| Project | IEEE 802.16 Broadband Wireless Access Working Group < <u>http://ieee802.org/16</u> > | | |
|------------------------------------|--|--|--|
| Title | 802.16g_D6 GPCS_PROTOCOL_TYPE encoding Issues | | |
| Re: | 802.16g_D6 | | |
| Purpose | Consider and adopt the proposed changes to 802.16g_D6 as the resolution of David Johnston's sponsor ballot comment against 11.13.19.5.1 | | |

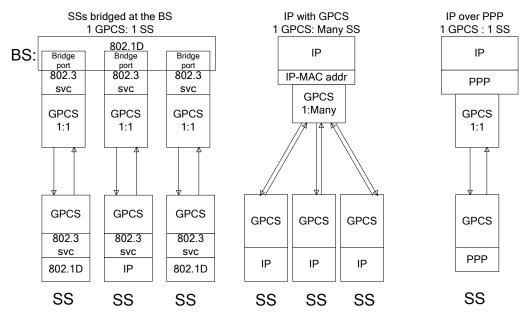
The relationship between GPCS instances and SSs needs to be clarified. To support GPCS-as-protocolmultiplexer style operation, 1 GPCS at the BS : many SSs should be allowed. To allow multiple point to point links with a bridge making the routing decisions, a 1:1 mapping should be allowed. It would be permitted for a BS to simultaneously provide a mix of such models, with SSs mapped to different GPCS instances either individually or in groups.

In the case of a GPCS instance at the BS peered with a single SS, the MS MAC Address primitive parameter on the GPCS_DATA primitive would be constant, set to the address of the peer MS.
